VIRGINIA POLYTECHNIC INSTITUTE AND STATE UNIVERSITY
PROCUREMENT DEPARTMENT

ADDENDUM NO. 1

DATE:	January 28, 2026
TO:	All Offerors
FROM:	Deirdre Curry, Contracting Officer
TOTAL PAGE(S):	7 page (not including attachments)
SOLICITATION TITLE:	VT Military Building Renovation
SOLICITATION NUMBER:	443882606

1 | OVERALL ROOF PLAN
A-103 | Scale: 1/8" = 1'-0"

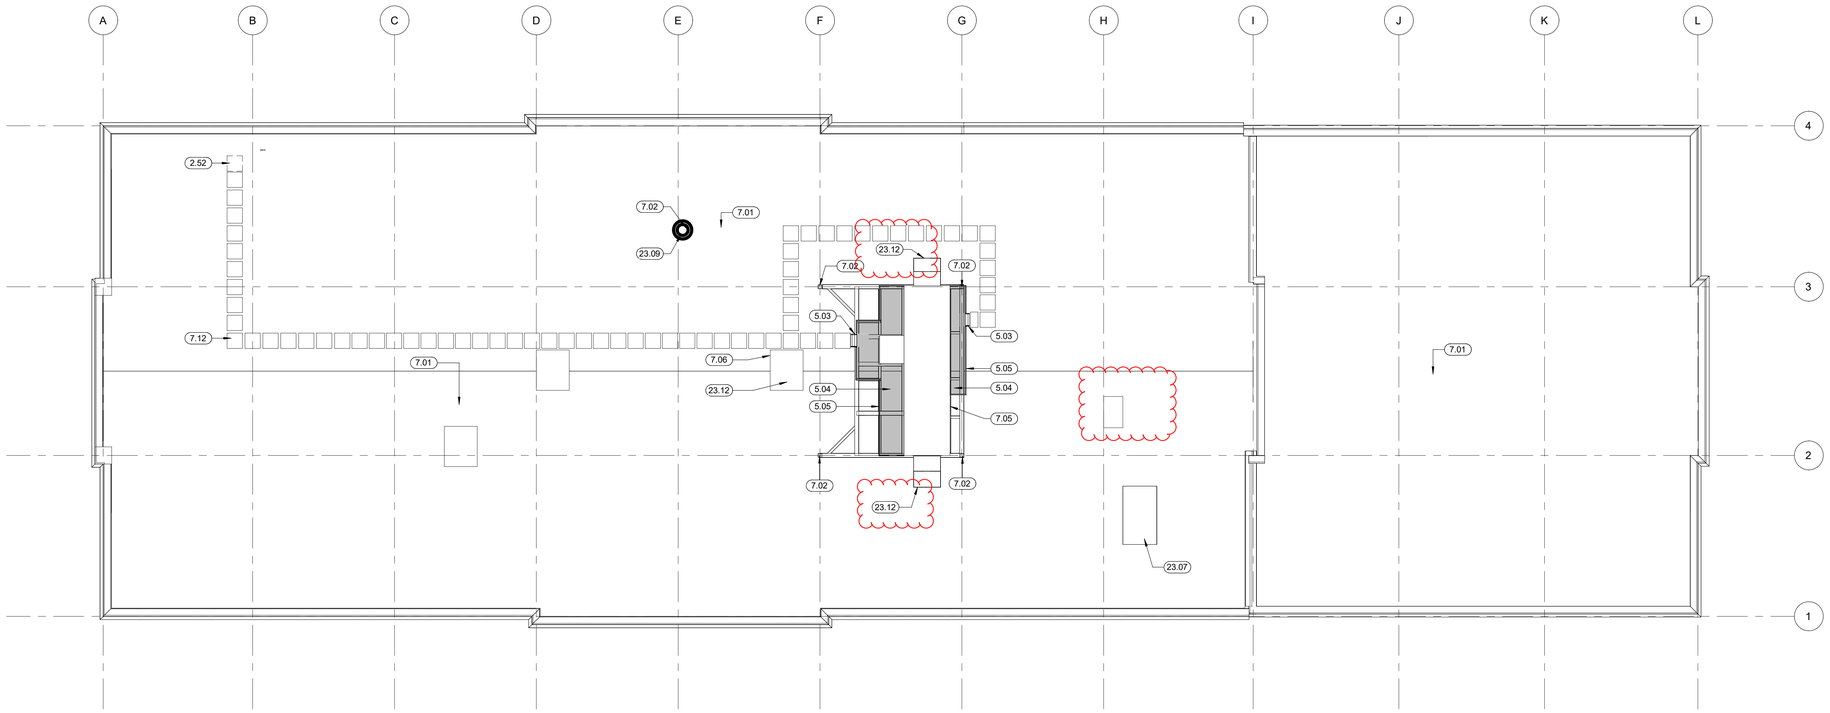
6. **Please provide roof warranty as references in Sheet 7.01 on sheet A-103.**

Virginia Tech Response*: See Roof Warranty in Exhibit D.*

1 **SECOND FLOOR INTERIOR FURNITURE PLAN**
A-901 Scale: 1/8" = 1'-0"

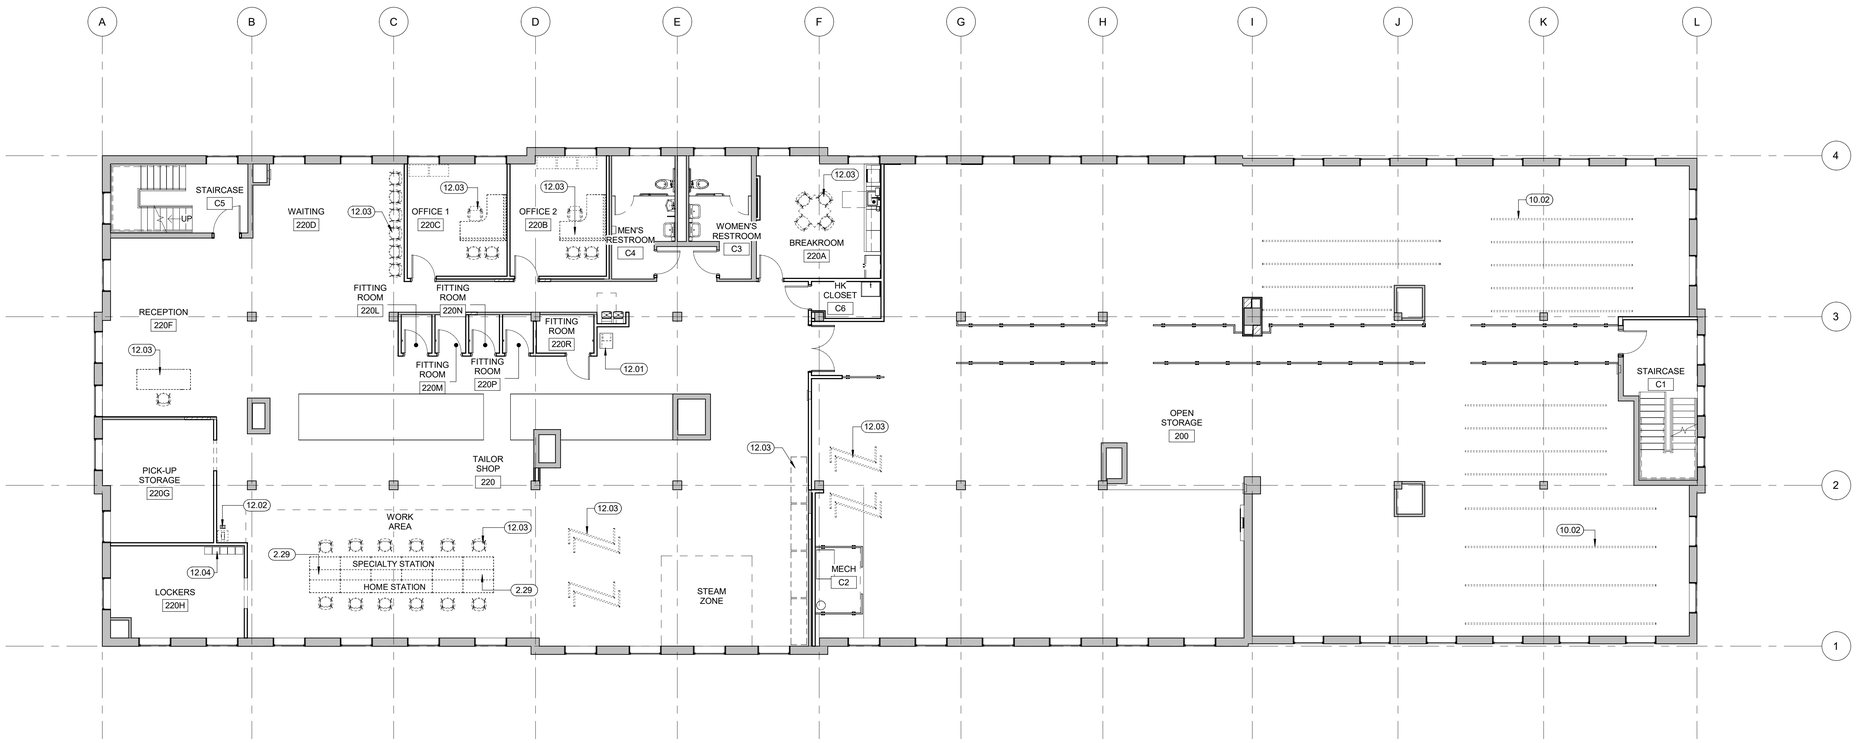
9. **Please provide locker specifications for lockers referred to in note 12.04 on A-901.**

Virginia Tech Response*: Lockers no longer in scope. Wall has been removed between Locker Room and Pick Up Storage room.*
